Denny Substation

**Department of Planning
and Development**
700 5th Avenue, Suite 2000
PO Box 34019
Seattle, WA 98124-4019

CIP Project and Street Vacation

PhaseDesign Development (CIP)
Public Benefit (Street Vacation)**Previous Reviews**[November 6, 2014](#)[April 3, 2014](#)[November 7, 2013](#)[June 6, 2013](#)[October 18, 2012](#)**Project Team Present****Phil Ambrose** Seattle City Light**Matt Ayer** Seattle City Light**Jenny Burns** Seattle City Light**Jennifer Clapham** KPFF**Michael Clark** Seattle City Light**Rachel Dotson** HBB**Gladys Dumo** Seattle City Light**Ryan Fagre** NBBJ**Kathy Fendt** Seattle City Light**Blake Fisher** NBBJ**Dean Koonts** HBB**Jose Sama** NBBJ**Greg Stamatiou** Seattle City Light**Sam Stubblefield** NBBJ**Carl Tully** NBBJ**Juliet Vong** HBB**Attendees****Beverly Barnett**

Figure 1. Update design for Lead Pencil's proposed sculpture "Transforest"

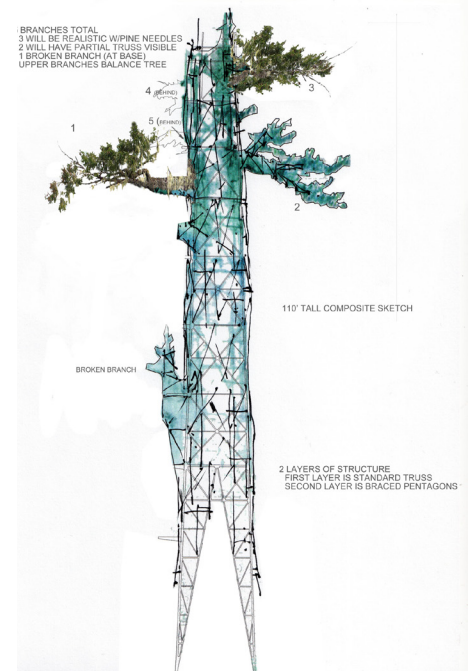
Studios on the proposed "Transforest" sculpture, shown in Figure 1.

10. Further study how the landscape design responds to a piece as powerful as "Transforest." Some of the geometries in this part of the open space appear unresolved and certain "remnant" spaces of landscape difficult to maintain. Be particularly mindful of how the artwork meets the ground.

Figure 4. A view east towards the proposed open space, with the Brewster apartments at left. The Commission discussed the materiality and design of the open space and off-leash area in relation to the building itself.

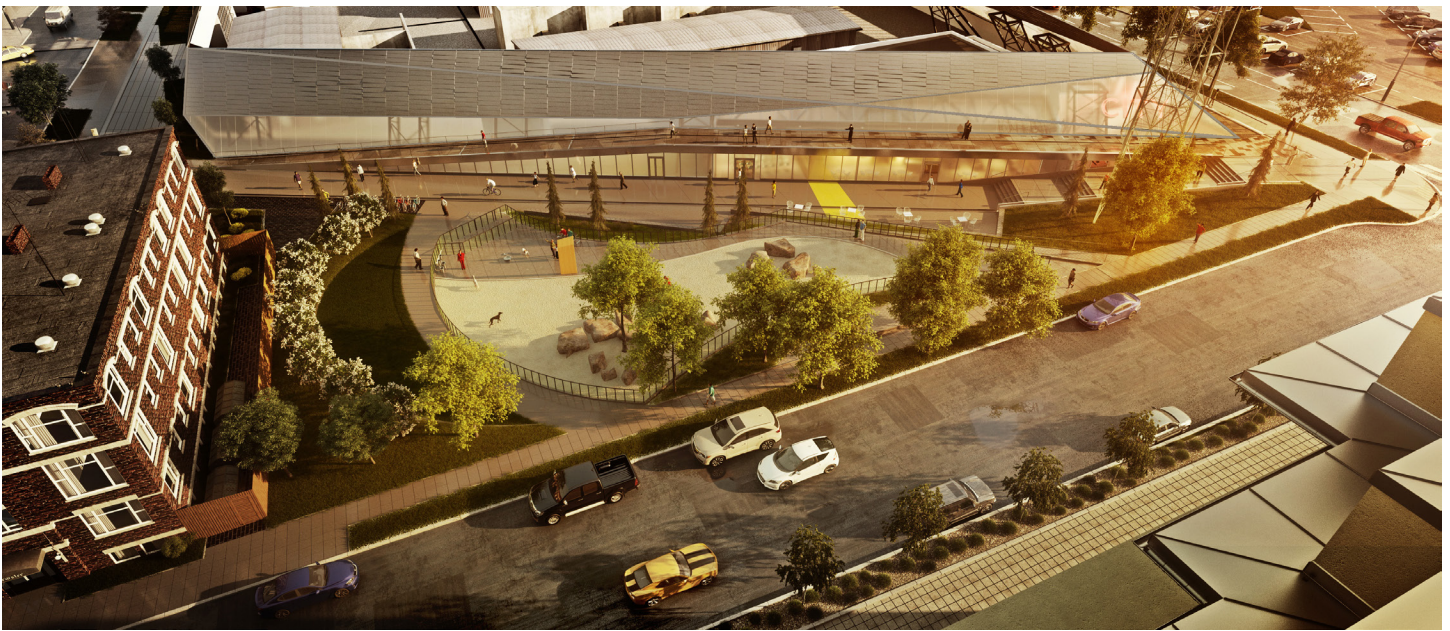
Much of the discussion focused on the materials and design of the open space and their relationship to the building, as shown in Figure 4. The Commission believed that greater integration of the open space and building vocabularies would help the elevated walkway experience feel more connected to the neighborhood. Some Commissioners suggested that changes to the fencing, seating, or size of the off-leash area could make the entire open space more welcoming to dog owners and non-dog owners alike; others argued that, if the community desires for an off-leash area, it should reflect the design and include amenities they want.

9. Integrate the materiality of the landscape with that of the building more thoroughly, particularly so that the elevated walkway experience feels more a part of the neighborhood.

Figure 5. Portals with infographics offer views to digital content displayed on yard equipment beyond.

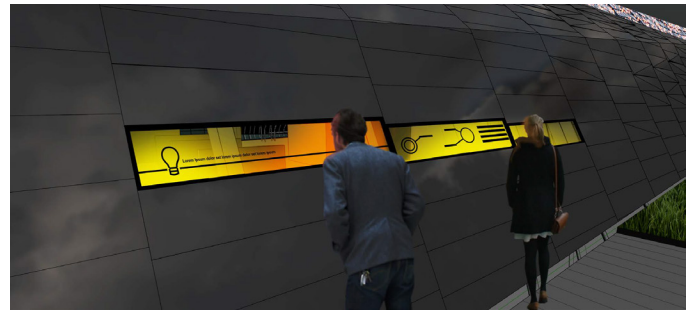
1. Develop a thorough and detailed plan for curating the content of the project's digital screens and acoustical elements shown in Figure 5. Ensure these features are integrated into the long-term operations strategy for the facility. Work closely with the Office of Arts & Culture so that the content remains fresh and maintained.

Figure 6. The Commission recommended dimming but not shutting off the lighting for Ned Kahn's "Switchwall" artwork.

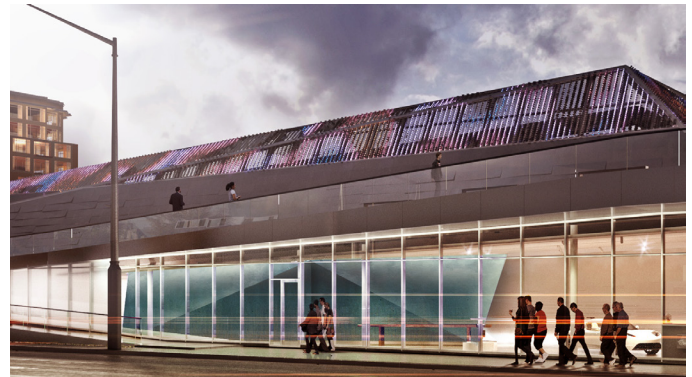
4. In response to concerns about light pollution, work with Ned Kahn to find ways to dim or moderate but not completely shut off the lighting of his piece during nighttime hours (Figure 6). Find the right balance so the lighting, akin to phosphorescence in water, is neither disruptive to neighbors nor a "black hole" of darkness.

Figure 7. The John St door could be part of the facility's curated elements.

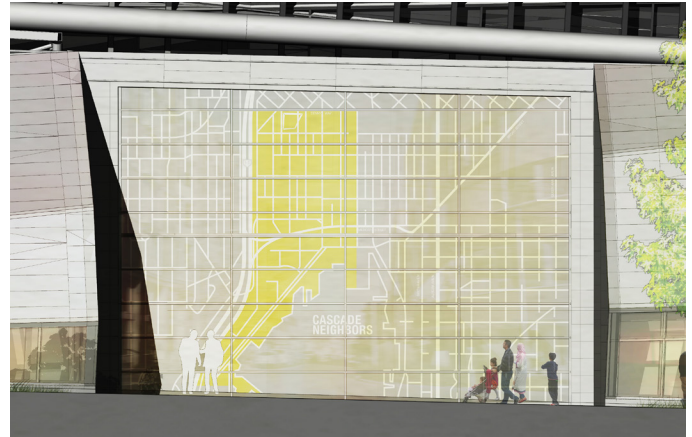
5. Consider a different graphic treatment for the John St door, perhaps as part of the project's curated or rotating content (Figure 7).
6. The Commission is supportive of the overall materiality and finds the variation and combination of metal and glass quite successful. That said, reexamine the balance of durability and warmth in material selection, the latter of which is lacking in places. Consider expanding the wood shown in seating and signage posts to other parts of the design, especially where people are interfacing with the facility (Figure 8).

Figure 9. The team should reexamine the interface of the community space and open space.

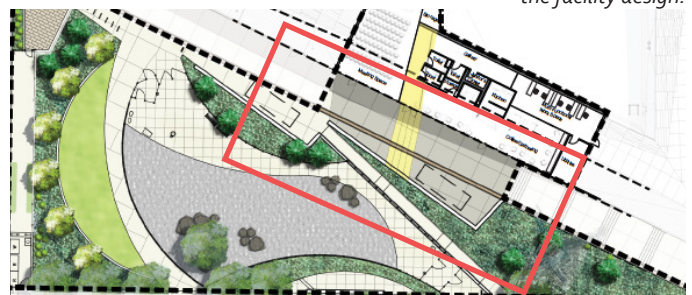
7. Pay close attention to the modulation and detailing of the translucent glass.
8. While the Energy Innovation Center shell space appears well integrated into the streetscape, the interface between the community space and the landscaped open space warrants further attention so that they become a seamless and unified public space (Figure 9).

Figure 11. Though it praised the inclusion of the bus shelter, the Commission again recommended the team look closely at how waiting and queuing affect the use of the sidewalk and entry to the Energy Innovation Center.

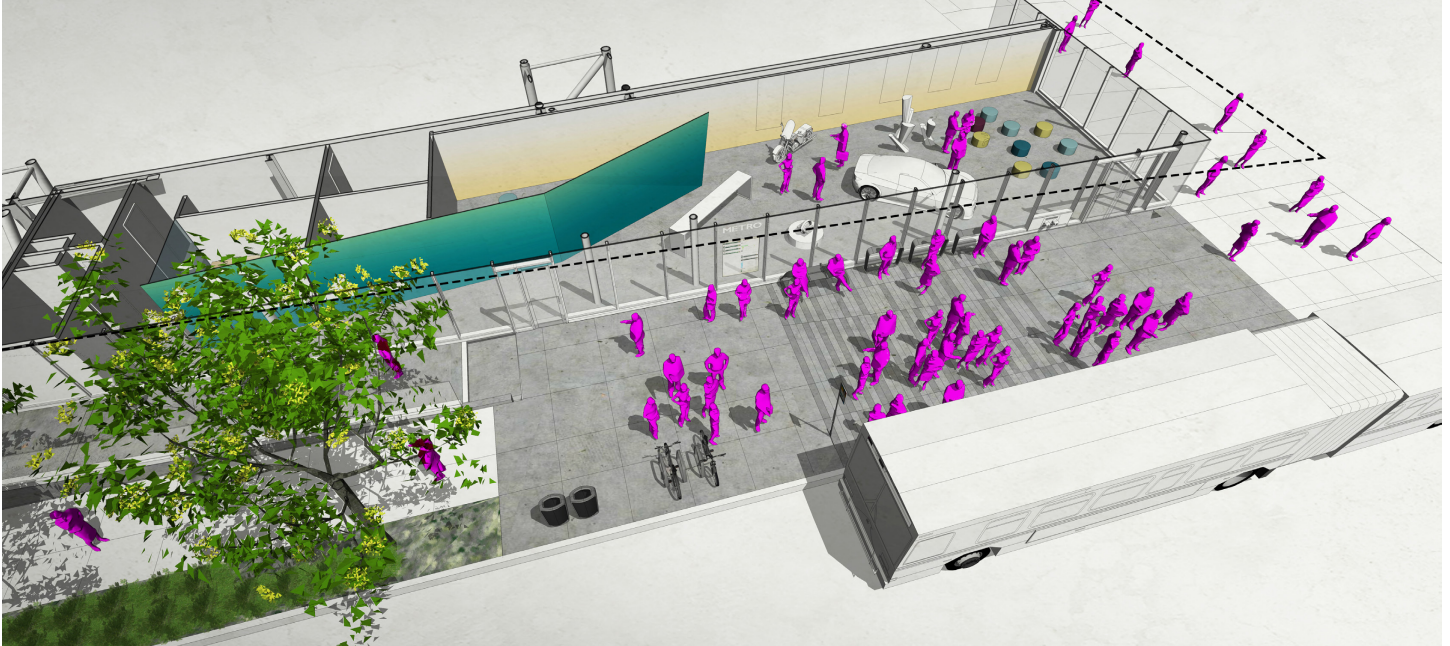
- Continue to analyze functionality of the bus waiting and queuing area to understand and evaluate the potential for crowding and the use of the sidewalk.
